Request for more information – Eastern Hill Notice of Requirement

Please find below our response to your letter dated 14 May 2024 requesting additional transport information. Our Transport Engineer has provided the following information in reply to the peer review carried out by Harriet Fraser Traffic Engineering & Transport on behalf of Hutt City Council.

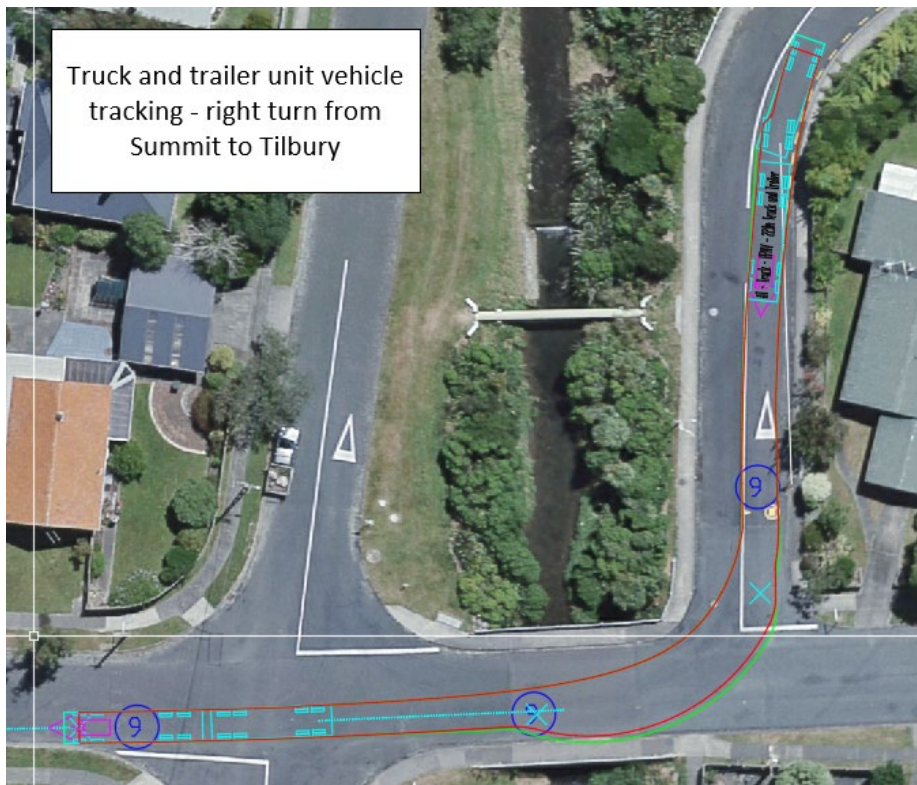
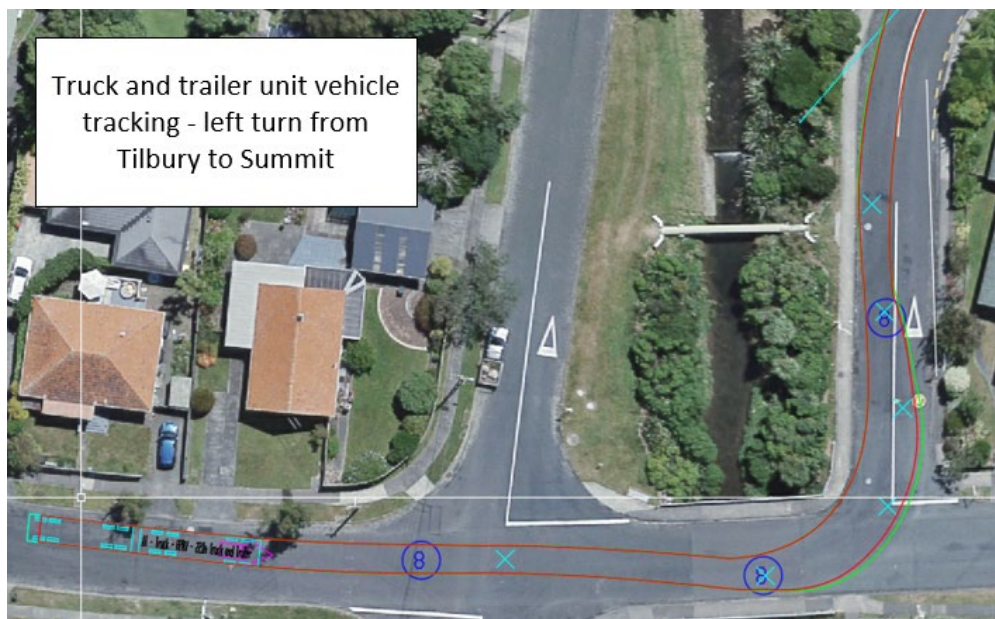
Please demonstrate truck and trailer swept paths through the Tilbury Street/ Summit Road intersection.

Please see images below which show a truck and trailer swept path through the Tilbury Street/Summit Road intersection. The swept paths demonstrate that a truck and trailer can successfully navigate this intersection.
